PHILADELPHIA ELECTRIC COMPANY

January 28, 1985

SUBJECT: Limerick Generating Station, Units 1 and 2, Organizational Changes  
in the PECO Electric Production Department

Attached are draft changes to FSAR Section 17.2, Figures 17.2-2, 3, 4, 5, & 15 and related 260 Series questions which describe the subject changes. These changes have been reviewed and it has been determined that the changes do not reduce the commitments in the QA Program previously approved by the NRC.

FIGURE 17.24

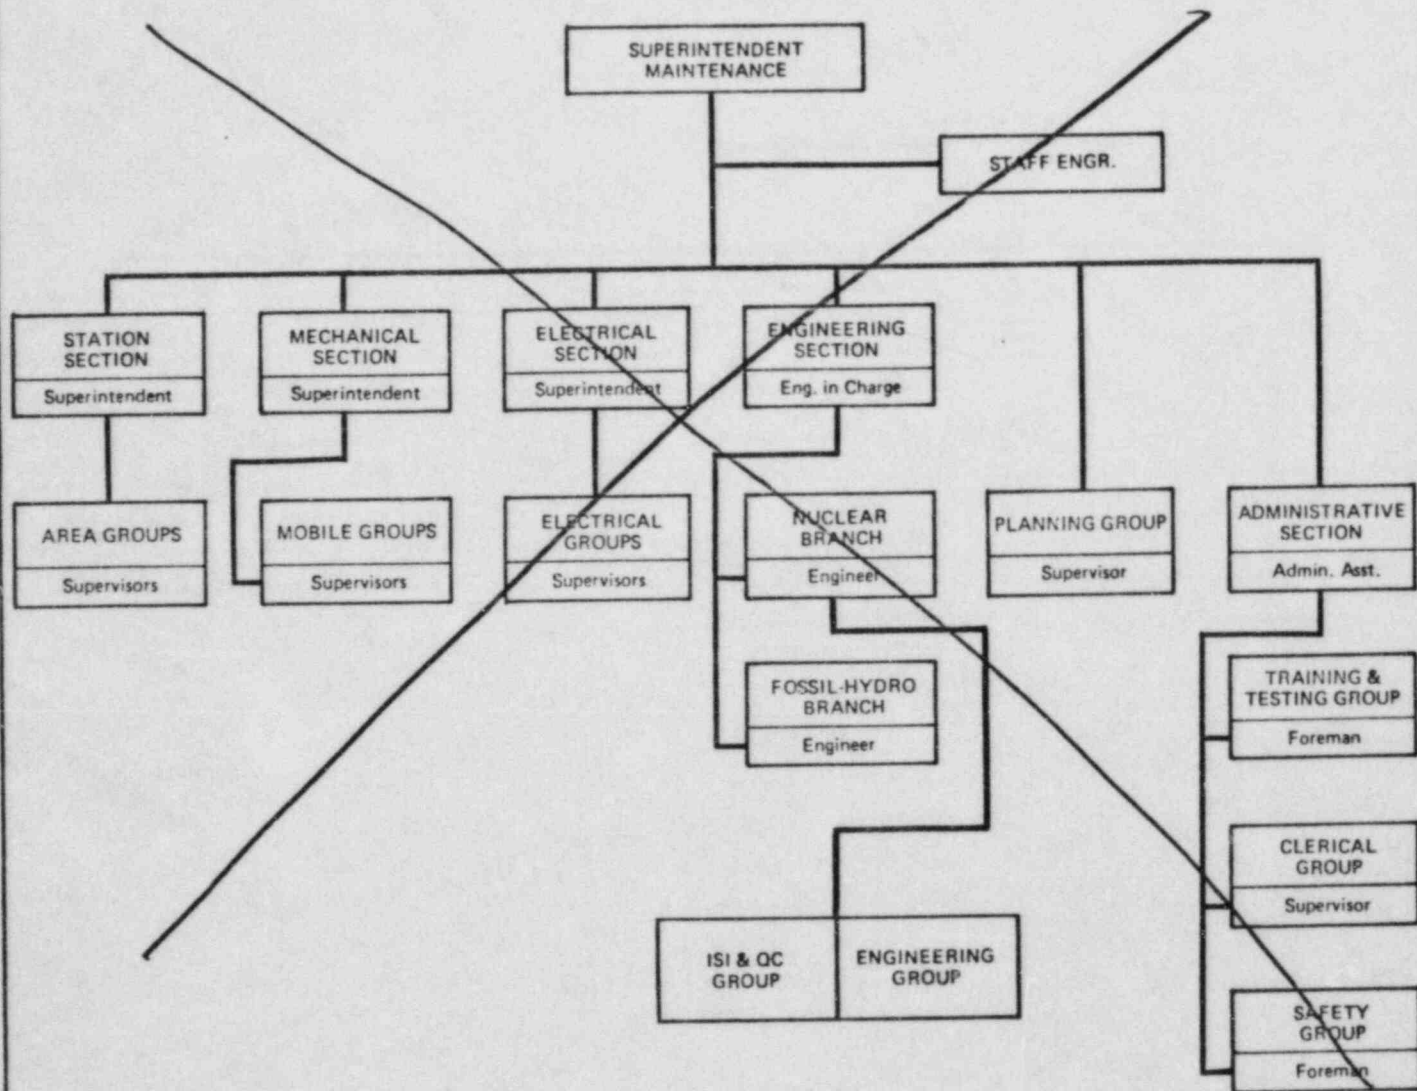
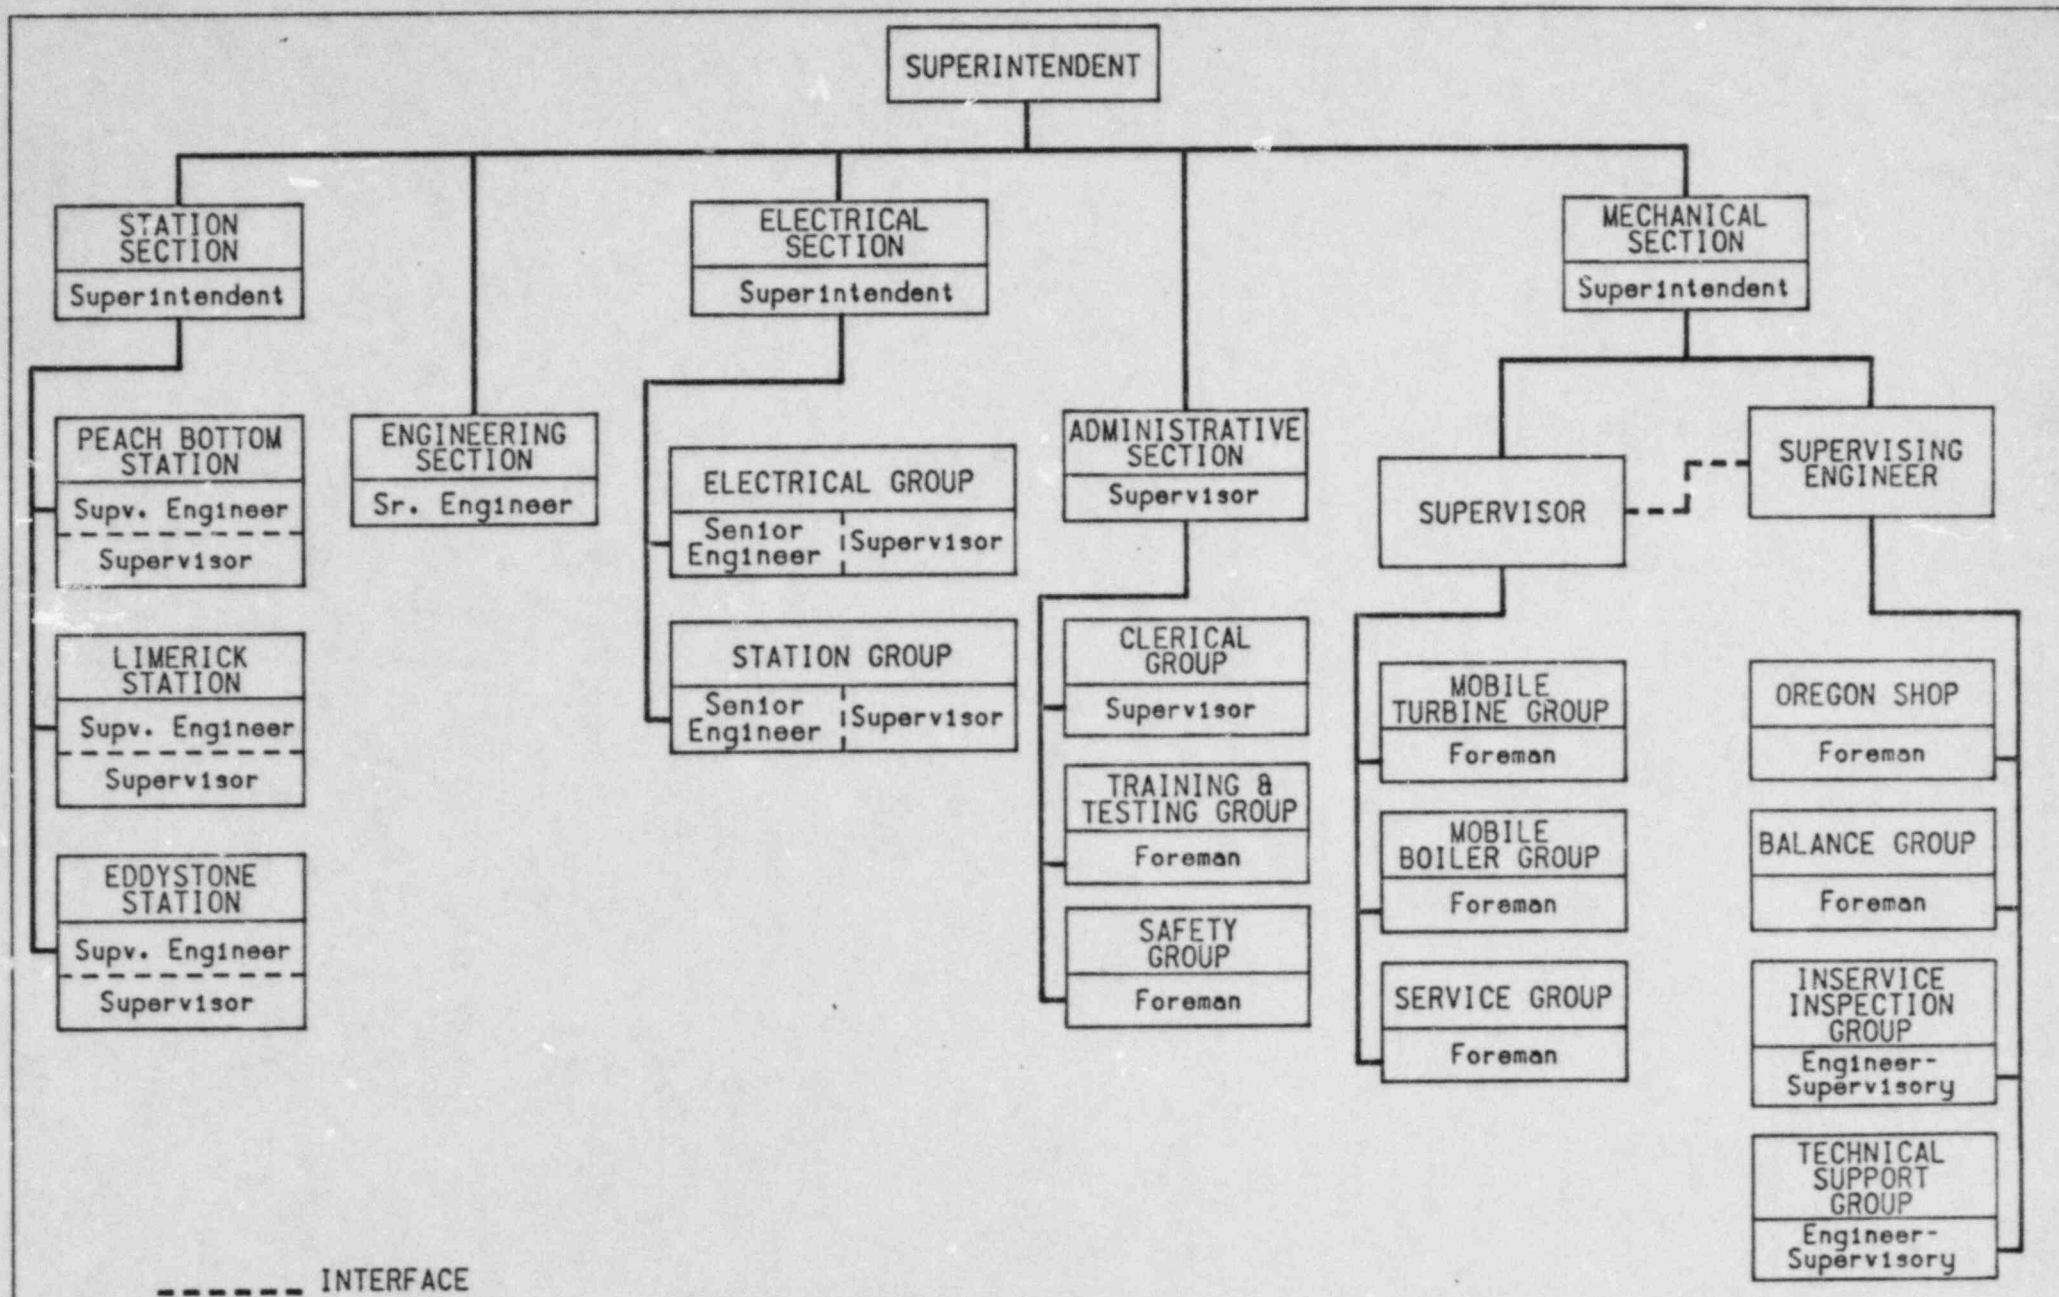
The Maintenance Division (Figure 17.2-4), under the <sup>supervision of a</sup> ~~Superintendent who reports to the Office of the Vice President~~ <sup>Manager, Fossil/</sup> ~~Electric~~ <sup>Hydro</sup> Production, is responsible for the Maintenance activities at all generating stations, <sup>and</sup> steam plants, and certain <sup>heating</sup> ~~substations~~. The Division is composed of ~~a staff engineer and~~ five sections: Station, Mechanical, Electrical, Engineering, and

FIGURE 17.2-5

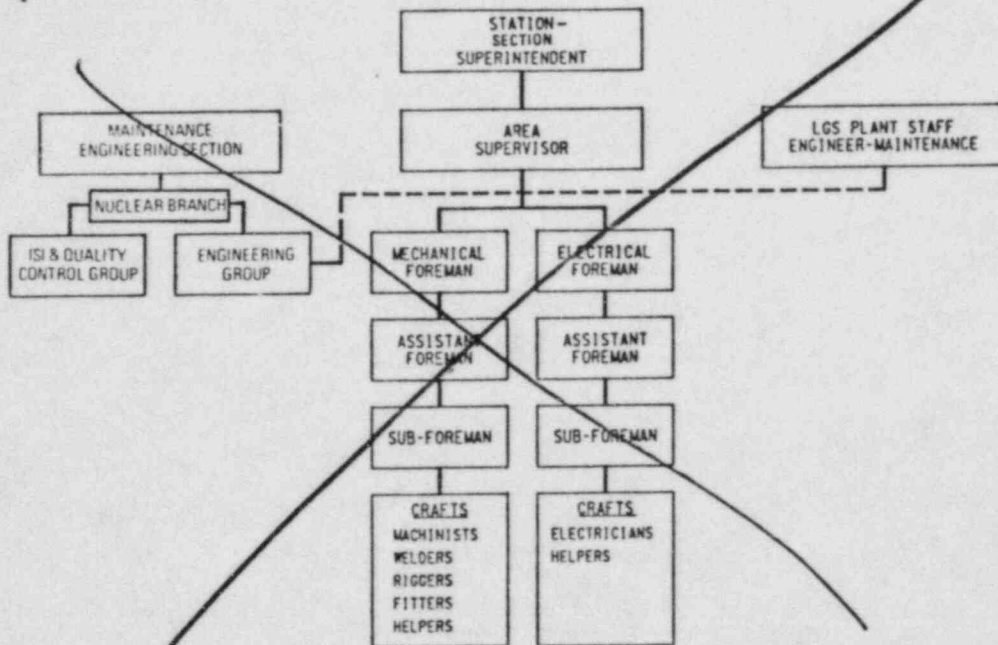
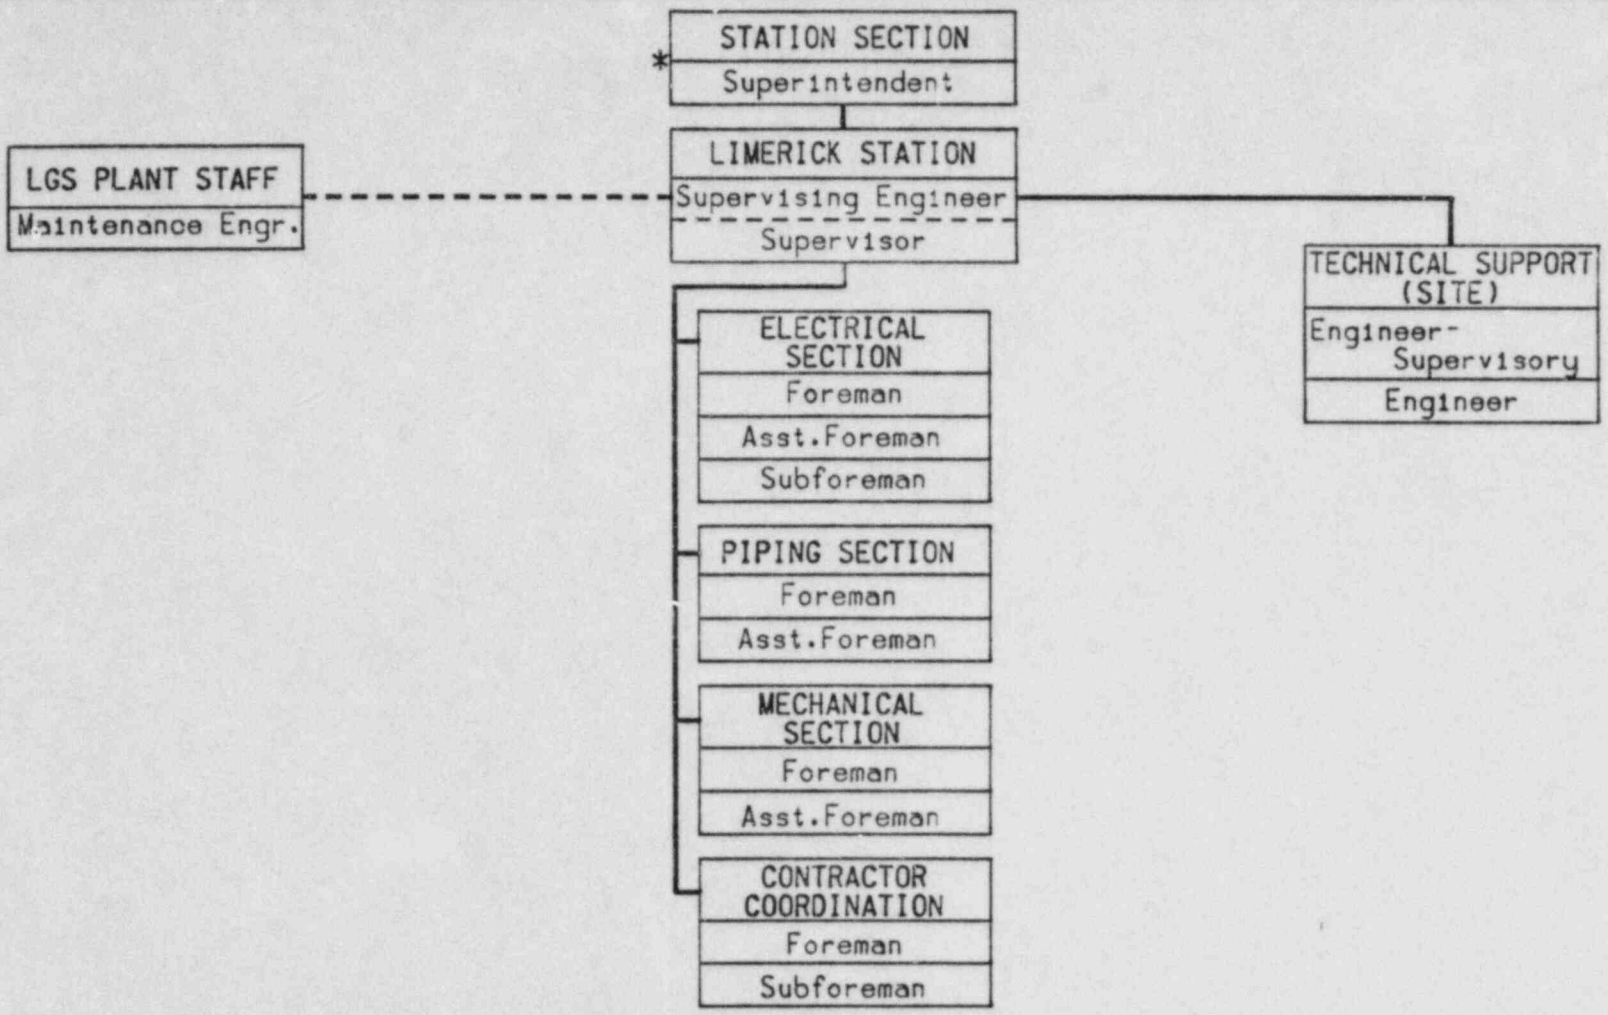
The interface between station maintenance forces, the operating staff and Maintenance headquarters is shown in Figure 17.2-5.

FIGURE 17.2-15

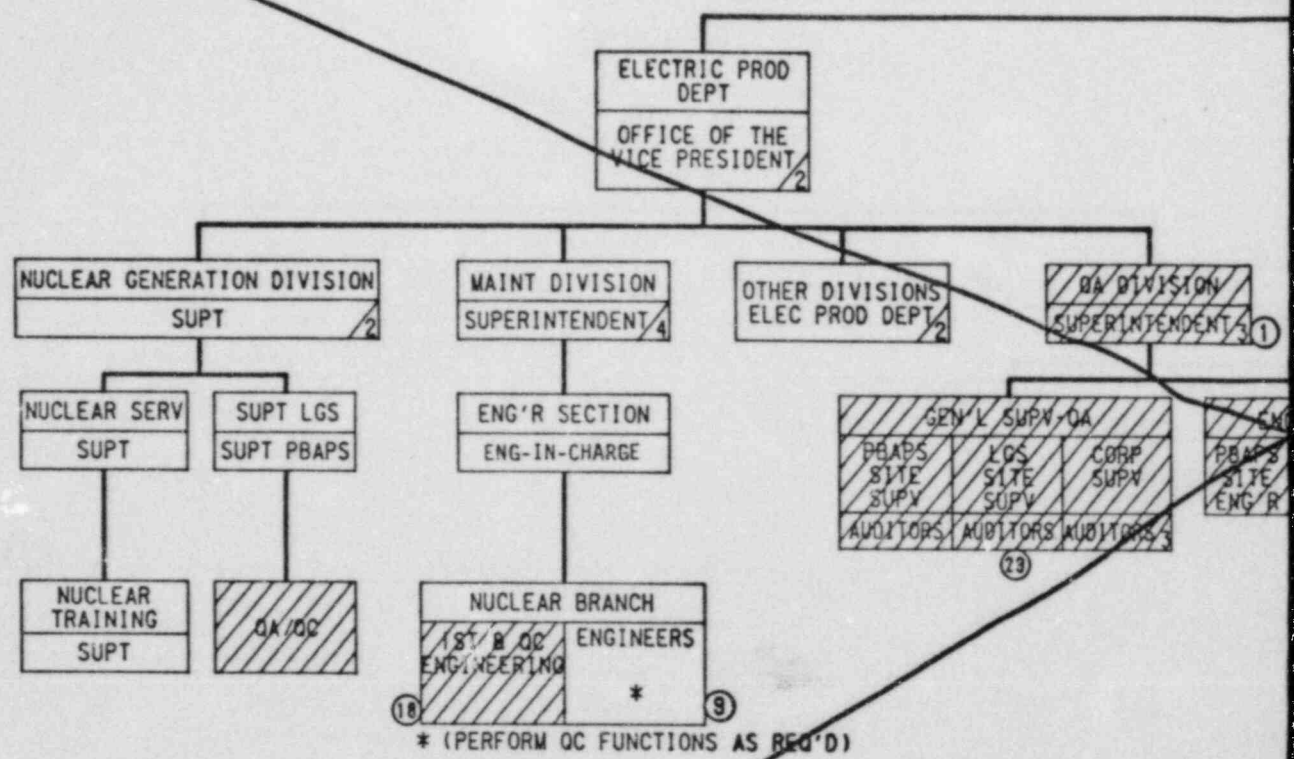
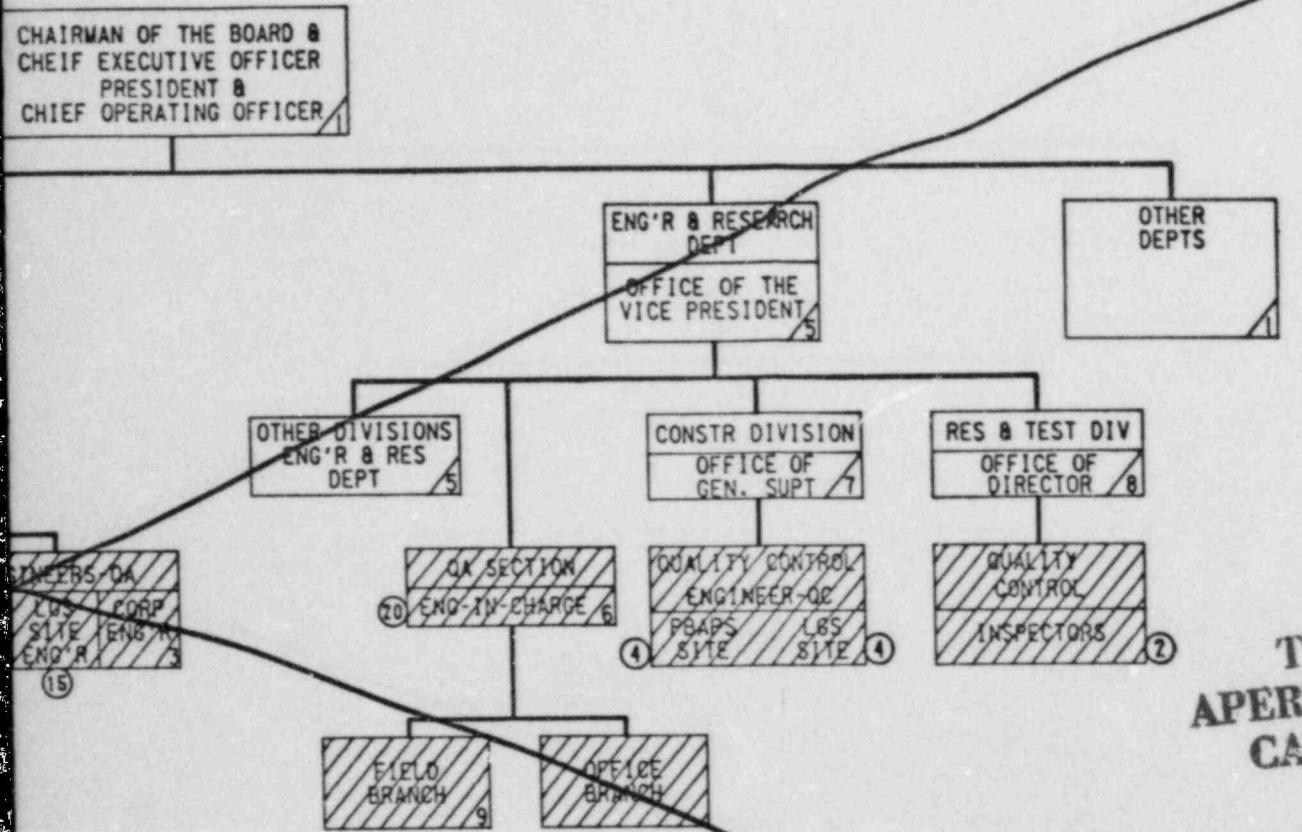
Figure 17.2-15 is a functional QA/QC Diagram of organizations performing within the Electric Production Department and the Engineering and Research Department, and its

~~Figure 17.2-15~~ outlines the approximate personnel staffing for QA/QC organizations involved in Peach Bottom and Limerick Stations.
